# CITY OF ALBUQUERQUE

**RE: Lava Trails  
Grading and Drainage Plan  
Engineer's Stamp Date: 08/12/20  
Hydrology File: F10D011A**

## LAVA TRAILS GRADING & DRAINAGE PLAN

## RETENTION POND DETAIL

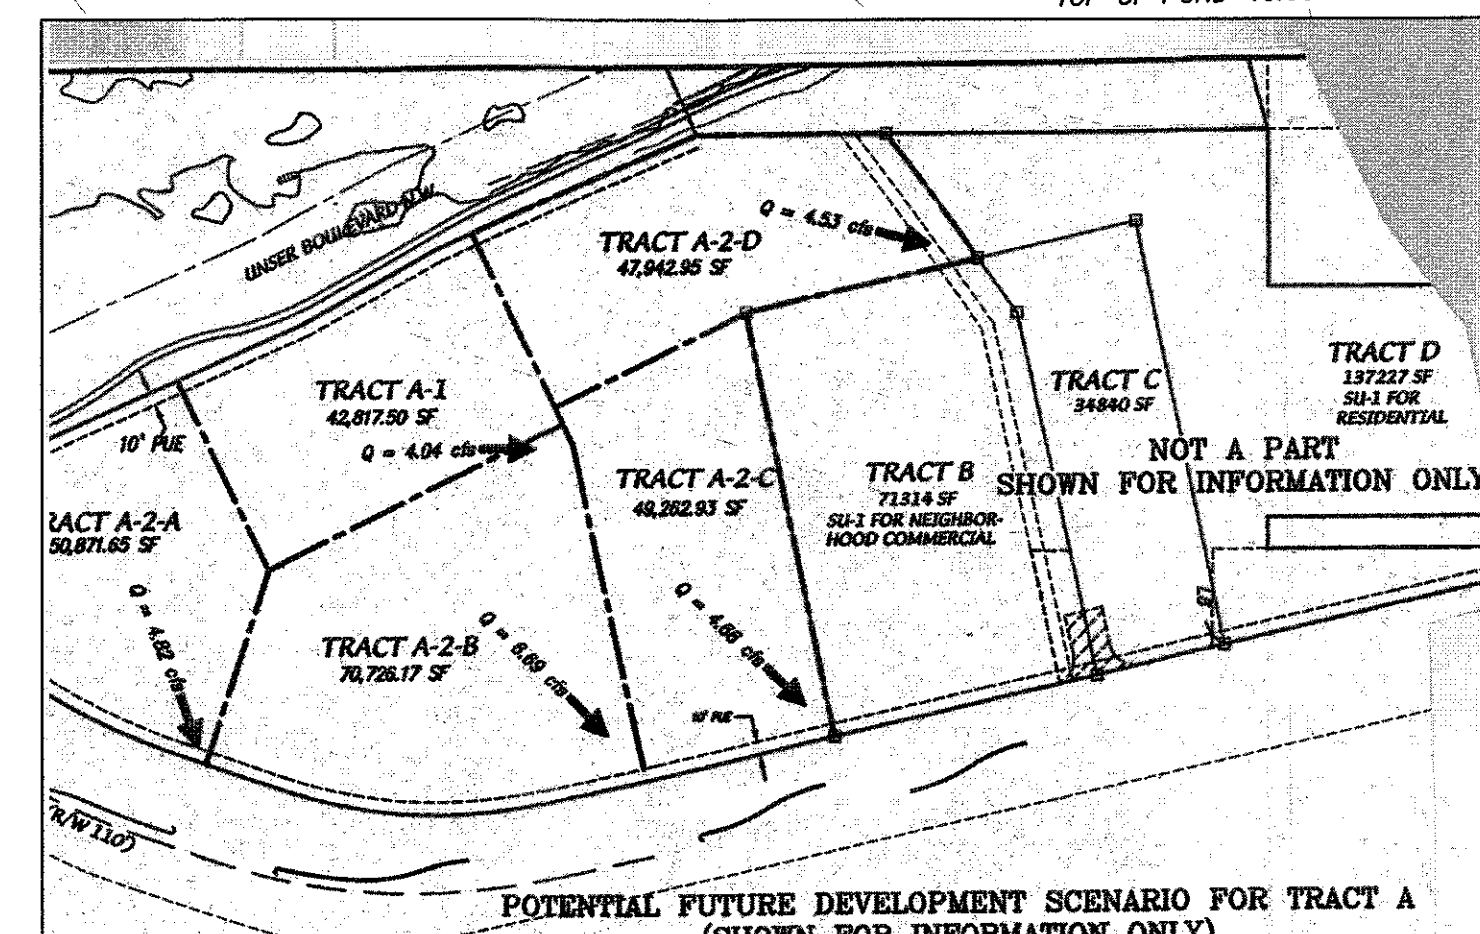
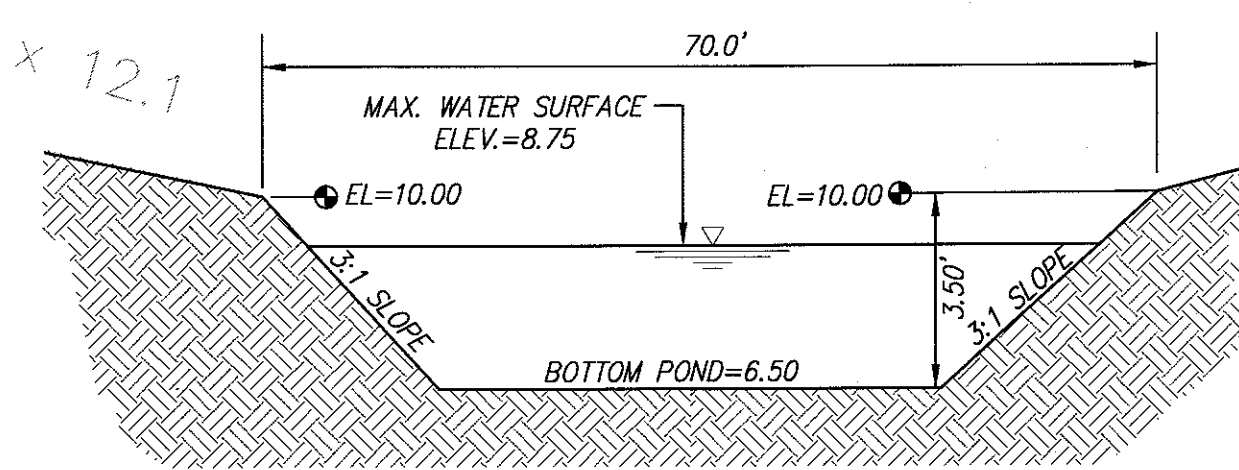
Once the grading of the retention pond is complete, a grading certification will be required. Please provide a Drainage Covenant for the proposed Retention Pond per Chapter 17 of the DPM either prior to or at the same time as the grading certification. Please submit this on the 4th floor of Plaza de Sol. A \$25 fee will be required.
